STAFF REPORT

CITY OF COLUMBUS PLAN COMMISSION (July 9, 2014 Meeting)

Docket No. / Project Title: PP-14-05 (Wildflower Estates 3)
Staff: Allie Keen
Applicant: JOLI Development, LLC
Property Size: 27.15 Acres
Current Zoning: RS3 (Residential: Single-Family 3)
Location: Located at the intersection of Wild Orchid Way and Daylily Drive, approximately 1,313 feet north of County Road 200 South, in the City of Columbus.

TYPICAL STREET SECTION - 50' R/W

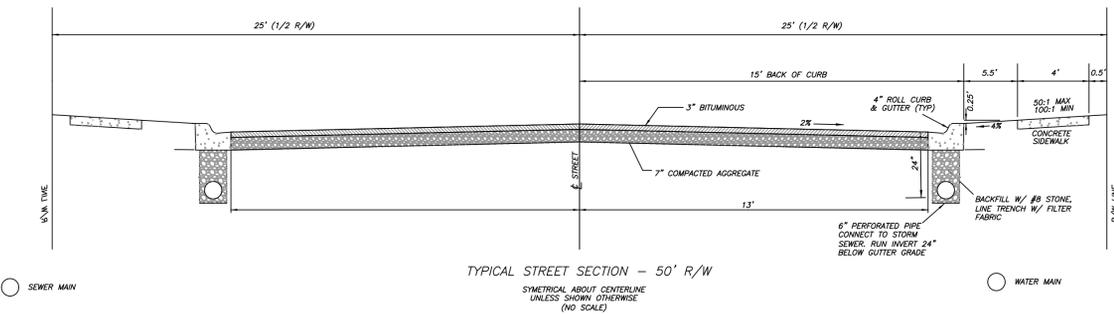
1. A modification from Section 16.24.030(Table 16.24-1) of the Subdivision Control Ordinance for the purpose of installing 30 foot wide streets, 1 foot wider than permitted for a Local, Residential, Suburban street.
2. A modification from Section 16.24.030(Table 16.24-1) of the Subdivision Control Ordinance for the purpose of installing 4 foot wide sidewalks, 1 foot less than required.
3. A modification from Section 16.24.070(A) of the Subdivision Control Ordinance requiring the installation of street trees on as a part of all major subdivisions along local streets. The applicant is requesting relief of this requirement.

2. Section 16.24.030(Table 16.24-1) of the Subdivision Control Ordinance allows for Local, Residential, Suburban streets to have a maximum width of 29 feet. This width includes the following: 8.5 foot travel lanes, 4 foot parking lanes, and 2 foot curb and gutter. The applicants are proposing a street width of 30 feet for the purpose matching the existing street width throughout the Wildflower development. The pavement on the streets will have 9 foot travel lanes as opposed to the required 8.5 foot lanes.

3. The Subdivision Control Ordinance standards changed in 2010 and also included the standards for sidewalk widths changing from 4 feet to 5 feet. All other subdivisions in the Wildflower neighborhood have been approved with 4 foot wide sidewalks. The applicant is requesting a modification to reduce the sidewalk width from 5 feet to 4 feet in order to be consistent with other sections and to provide a smooth transition between them.

- Table 16.24-1. The table allows for a maximum street width (including curbs) to be only 29'. A modification is being requested to allow for a 30' wide street .
- Section 16.24.060 & Table 16.24-1. This section requires a 5' wide sidewalk. A modification is being requested to allow for a 4' wide sidewalk.
- Section 16.24.070. This section requires Street trees. A modification is being requested to allow no street trees.

The previous sections of the Wildflower developments have not been required to install street trees, and have been constructed with 30' wide streets and 4' wide sidewalks. Additionally the water mains have been installed in the location of the required street trees. Without the requested modifications the transitions between the old and new sections would be troublesome and difficult to construct.

Approval with all modification requests, contingent on the technical comment being addressed.

SHEET:
5

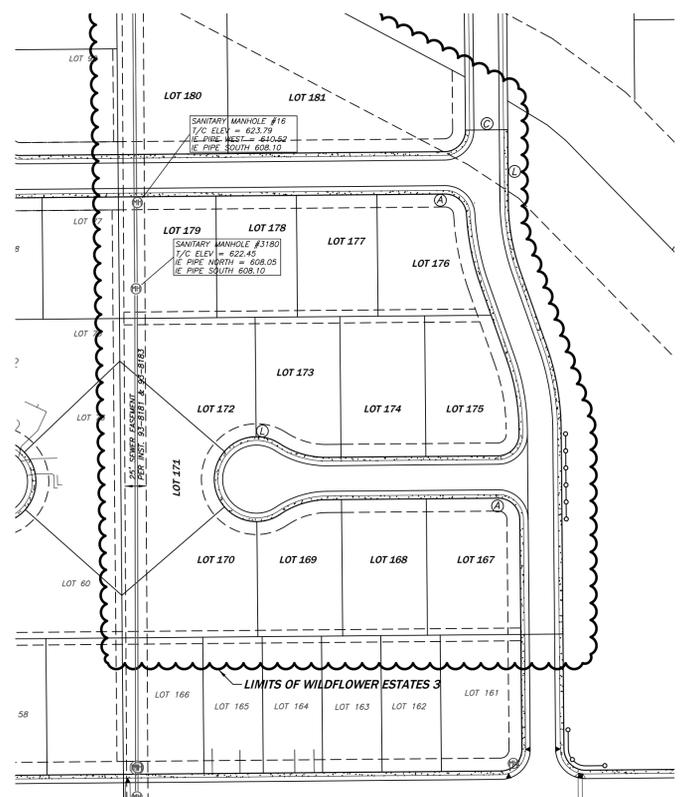
The following outstanding technical comments must be addressed by the applicant: Show the sidewalk ramp locations on sheet 5 for the proposed subdivision.

The relevant history of this application includes the following: The Subdivision Review Committee met on June 19, 2014, reviewed this application, and forwarded it to the Plan Commission. The following outstanding comments have not been addressed: Show the sidewalk ramp locations on sheet 5 for the proposed subdivision.
